# Comfit Composite Knit Ltd. (New Building)

4<sup>th</sup> June 2018

# Observations

Project : Construction of Proposed Seven-Storeyed Green Leaf Building-2  
Location: Comfit Composite Knit Ltd. at Gorai, Mirzapur, Tangail.

Bore layout plan

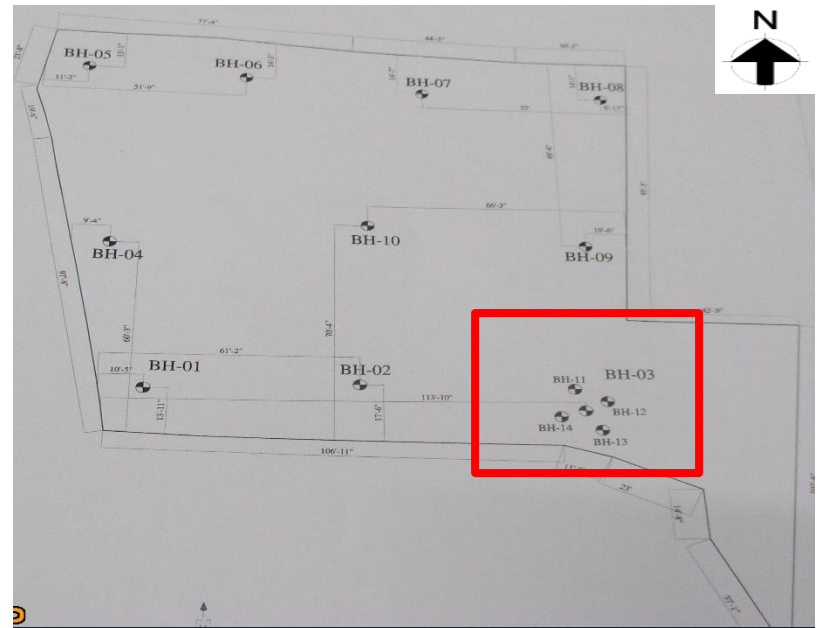
The allowable bearing capacity of BH-3,11,12,13,14 are relatively very low at 3 m depth compare to the design bearing capacity of 170 kPa. Soil improvement suggested in geotechnical investigation report to obtain the design soil bearing capacity. No soil improvement record was available on site for review. Building engineer is required to check whether the recommended improvement was carried out or not and review the foundation design accordingly.

Item No.	Observation	Recommended Action Plan	Recommended Timeline
1	No record available for soil improvement	Building engineer is required to check the existing soil bearing capacity and review the foundation design.	6-weeks
2	No record available for soil improvement	Carry out remedial works where necessary.	6-months
3	Live load plan need to revise	Maintain current use of loading below 3 kPa.	6-weeks
4	Live load plan need to revise	Update floor loading plan according to BNBC minimum live load requirement.	6-weeks
5	Columns susceptible to vehicle impact	Provide protective barrier to the suspected columns.	6-weeks

# Live load plan need to revise

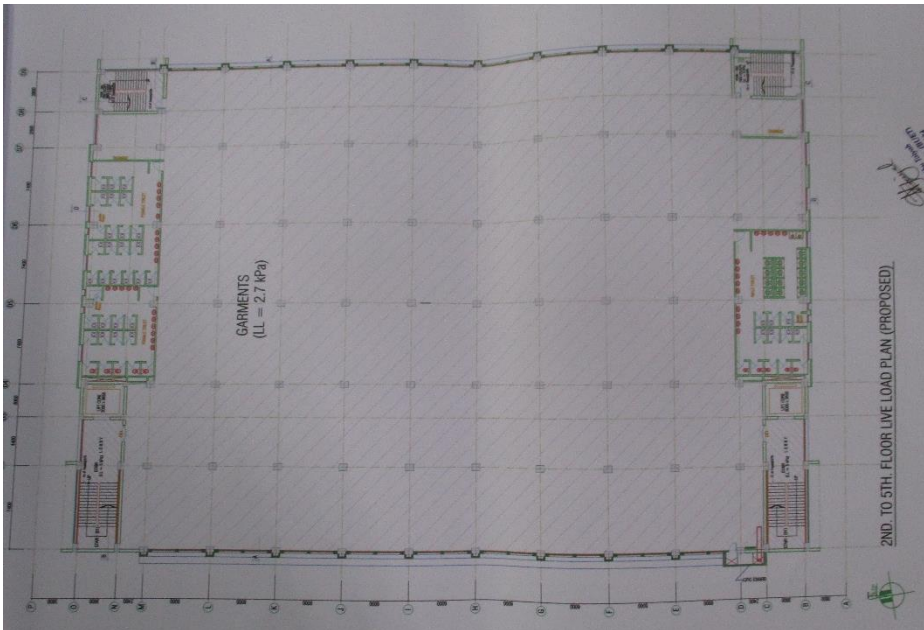
Live load considered 2.7 kPa on general floor and 7.5 kPa on first floor. Which is not meet the minimum standard according to BNBC. Building engineer is required to update the floor loading plan following minimum live load requirement as per BNBC.

No load management program was visible. Implement the floor load management program.
